900 NORTH 34TH STREET

02.27.2017 | 16-009 SDCI Project #3024100

DESIGN RECOMMENDATION

SUPPORTED MASSING SCHEME

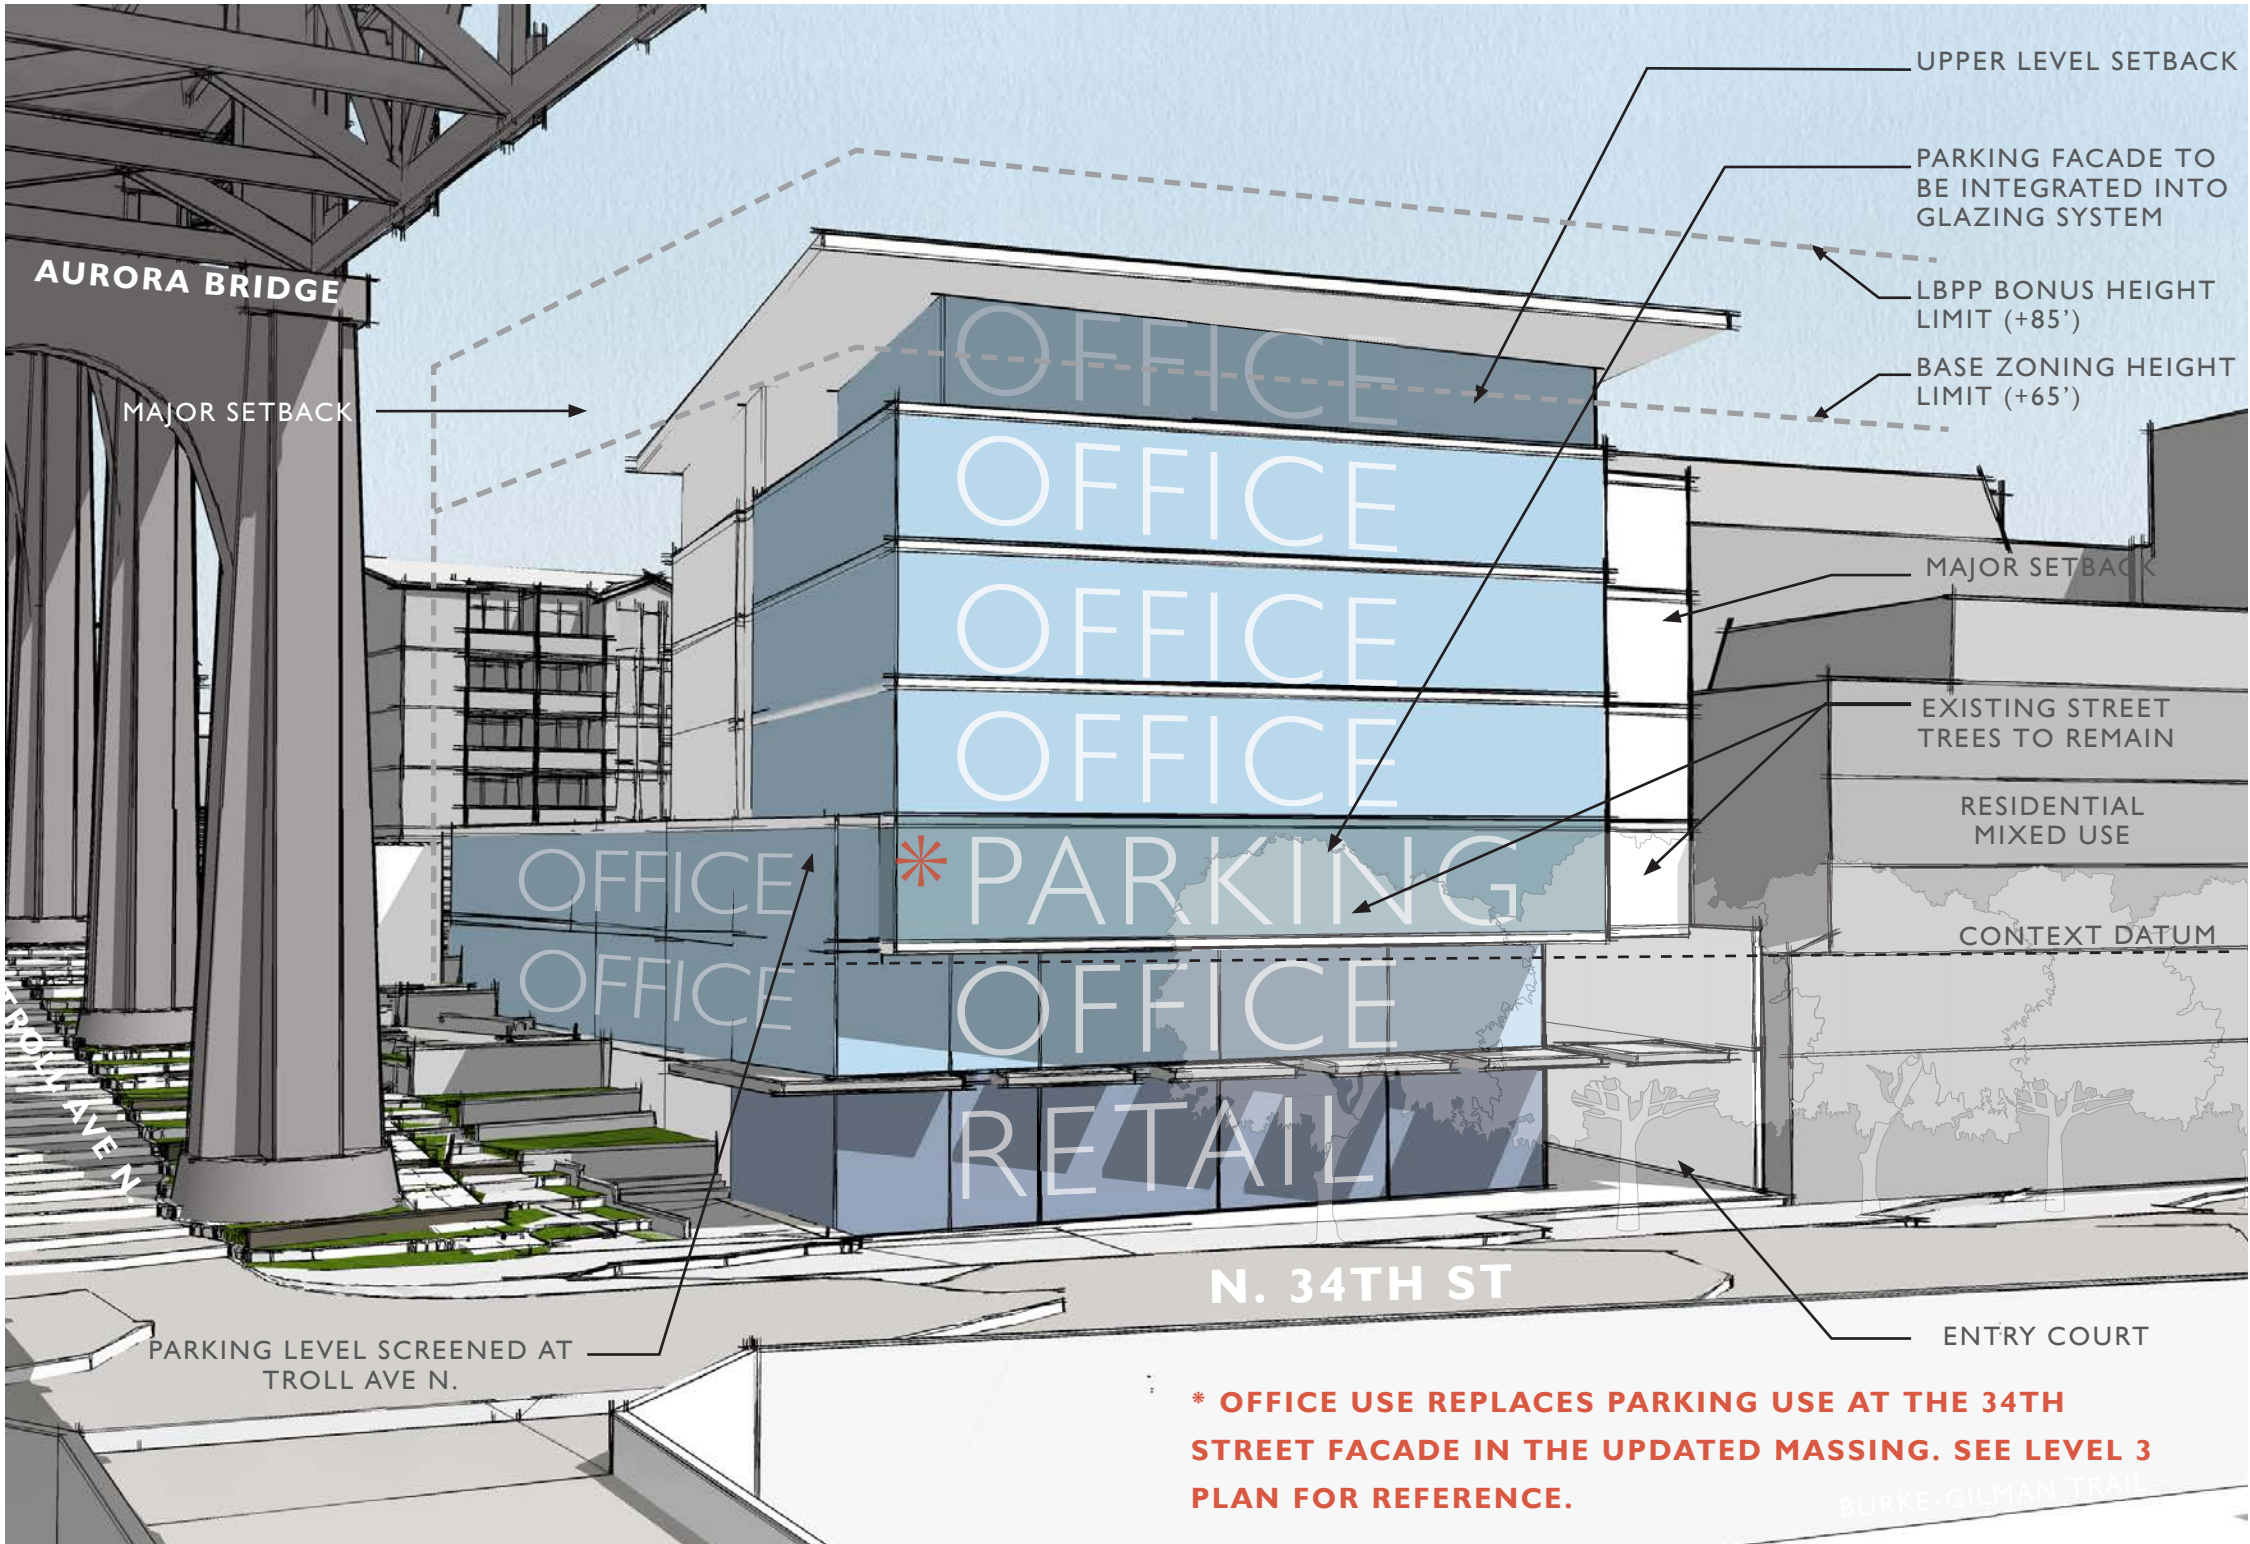
- Agreed with public comment to support the narrowing of the upper massing as this reduced the height, bulk, and scale, as well as, reducing shading. B-2, CS2-D, DC2-A

- Agreed that the rotated setback along Troll Ave was positive and created further visual interest at the corner. CS2-C
- Agreed with public comment and supported the building mass opening towards the adjacent courtyard to the east maintaining light and air access into the adjacent courtyard space. CS2-D

- With the next submittal, provide a window/privacy study and sections to clarify the relationship of the proposed building with adjacent buildings (east building adjacency) CS2-D-5 SEE PAGES 28-30 FOR RESPONSE

- With the next submittal, provide information on how the east blank walls will be treated and further detail of the north wall at the alley. DC2-B-2 SEE PAGES 28-30 FOR RESPONSE

VIEW FROM SOUTHWEST

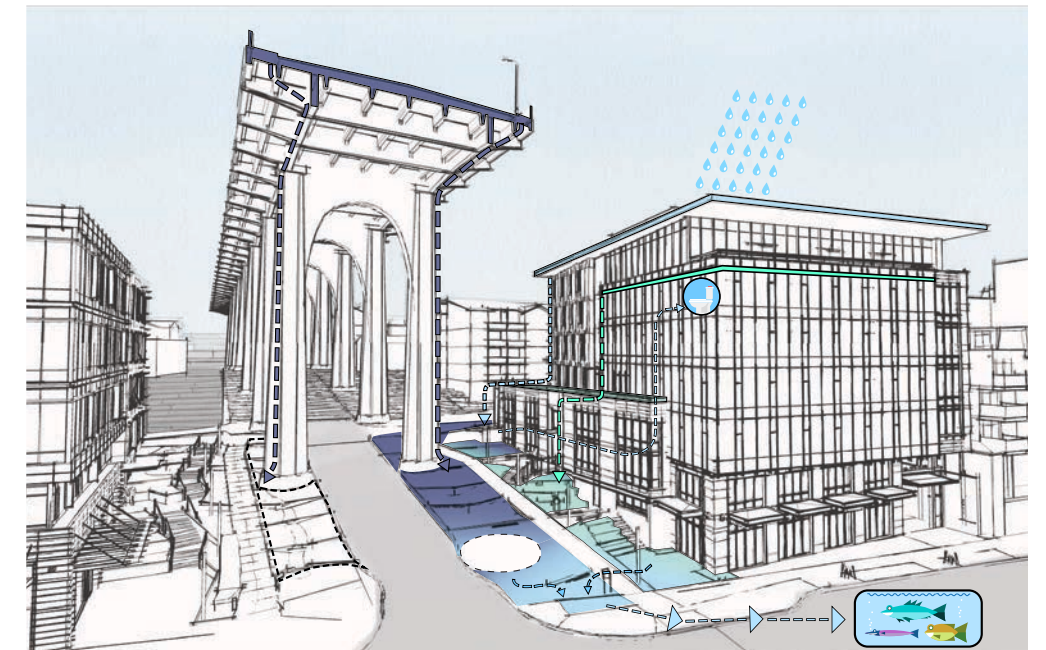
CSI-E-2 ADDING INTEREST WITH PROJECT DRAINAGE Use project drainage systems as opportunities to add interest to the site through water-related design elements.

APPLICANT RESPONSE: The project will capture rainwater falling on the large overhanging roof, and deliver this to a detention tank for non-potable reuse in the building (toilets and irrigation). The rainwater capture is celebrated through activated rain leaders on the north facade, and with a water feature inset at the northwest corner of the project, facing the Troll Ave sidewalk.

EAST FACADE SECTION

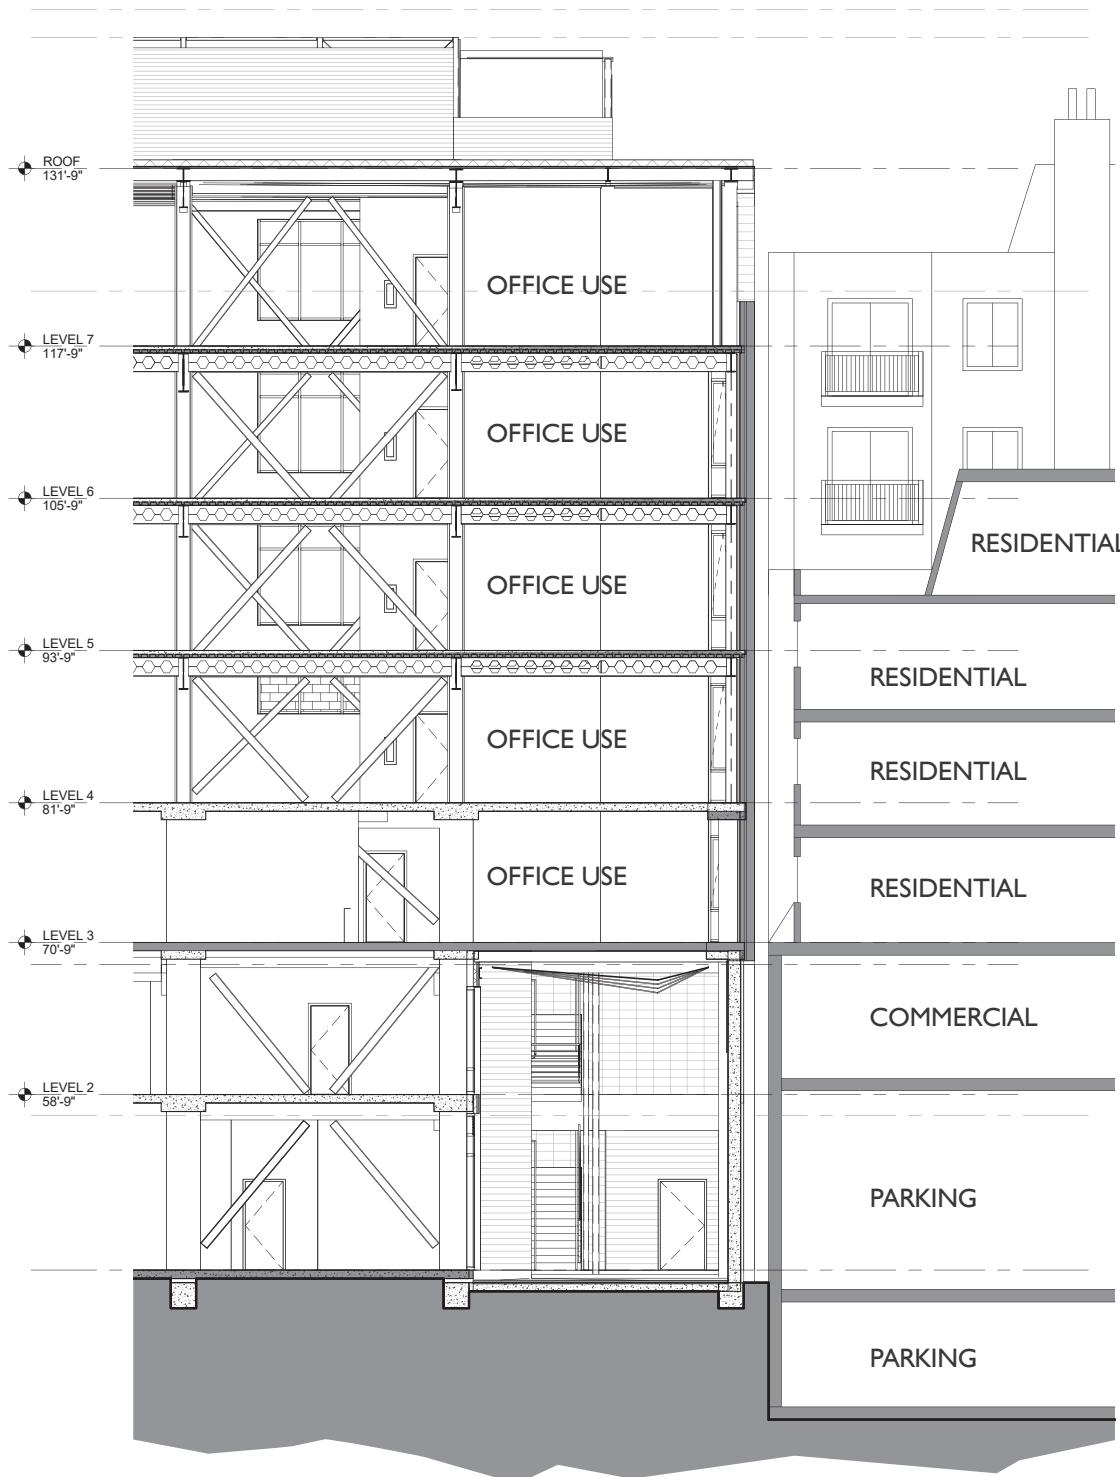
BOARD DIRECTION AT EDG: With the next submittal, provide a window/privacy study and sections to clarify the relationship of the proposed building with adjacent buildings (east building adjacency.)

APPLICANT RESPONSE: We conducted a study of the windows of the adjacent residential building to the east in both plan and section. The project responds to this proximity first through the massing of the eastern light court, referencing the adjacent building’s courtyard and providing relief and additional sunlight. Also, the patterning in the east party wall of our project has been developed to provide visual interest for the neighbors.(See pages 24-25)

EAST FACADE DESIGN STUDY

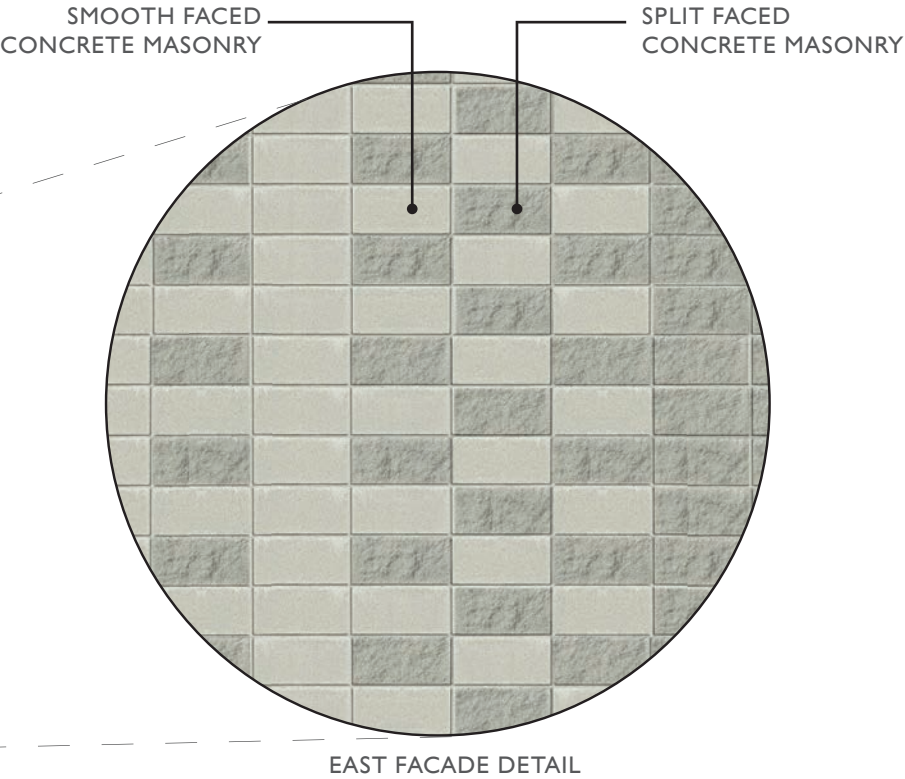
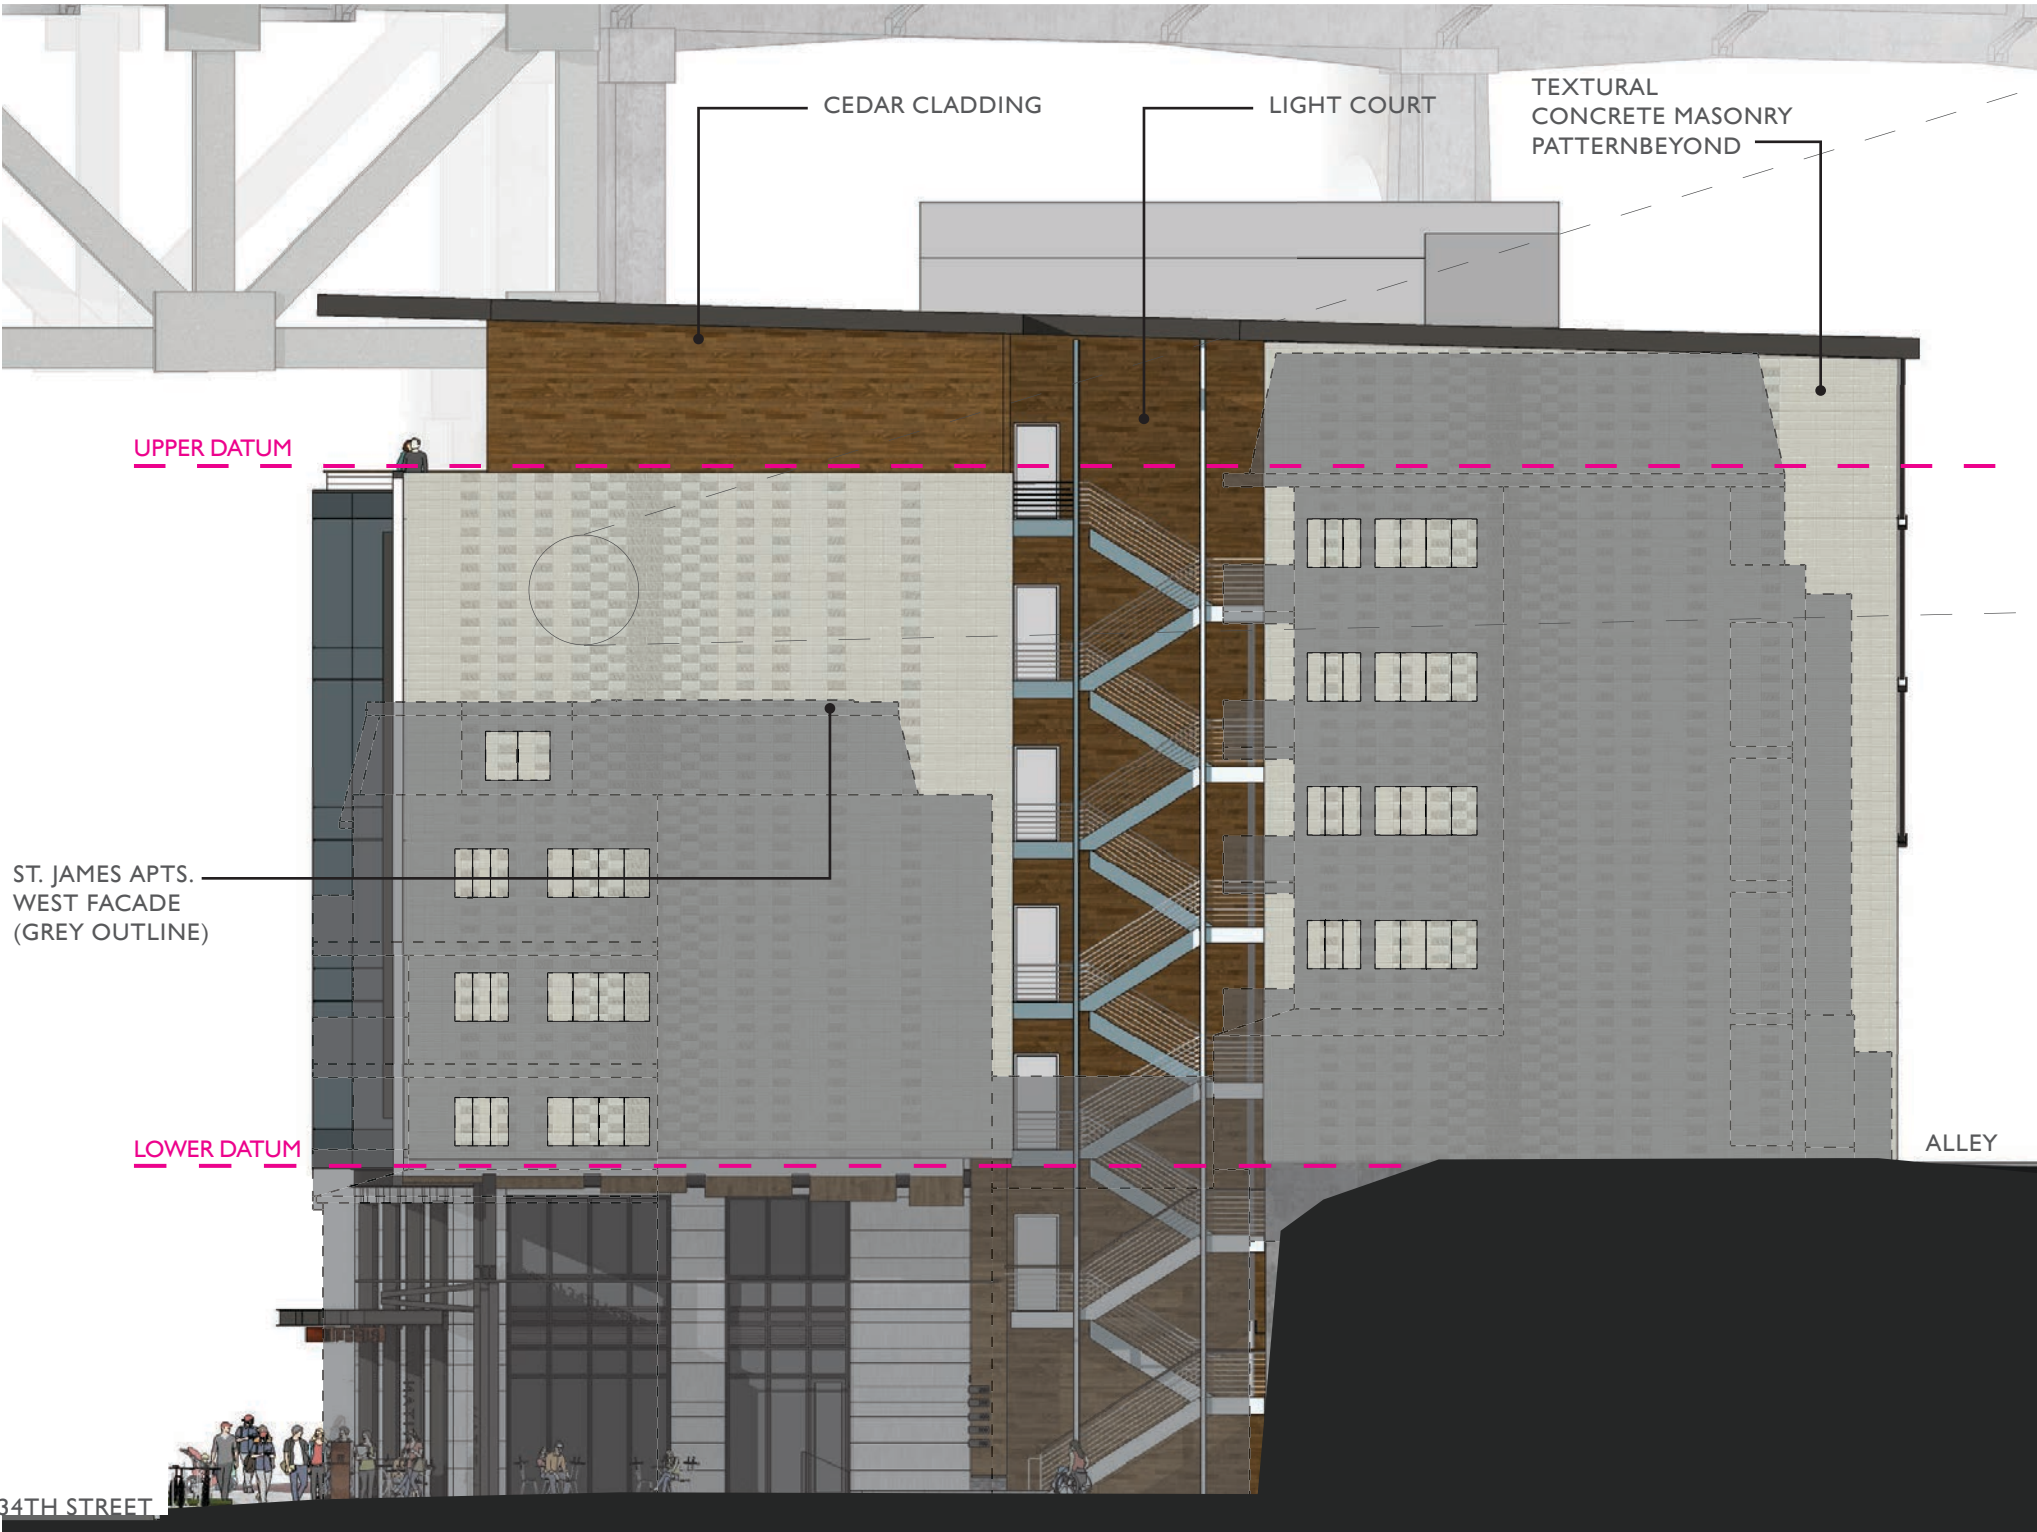
BOARD DIRECTION AT EDG: With the next submittal, provide information on how the east blank walls will be treated and further detail of the north wall at the alley.

APPLICANT RESPONSE: The proposed design highlights the water capture strategy of the Living Building Pilot Program by integrating a series of steel channels that transports rainwater from the upper roof down the north facade. This creates a visible element that breaks down the facade and integrates with the punched window pattern. Window elements were placed carefully to minimize visual conflicts to the low rise neighborhood to the north. A cable vine trellis has been integrated to screen views from the upper floors and to naturally soften the facade facing north.

The east walls, on either side of the light court, are required to have a fire rated assembly and windows are not allowed on these faces. The blank walls have been mitigated through the arrangement of a gradient CMU pattern between smooth and split-face units, creating a subtle, textural pattern that will provide visual interest for the adjacent residential units to the east. The southeast portion of the top floor is recessed three feet and clad in a warm cedar cladding.
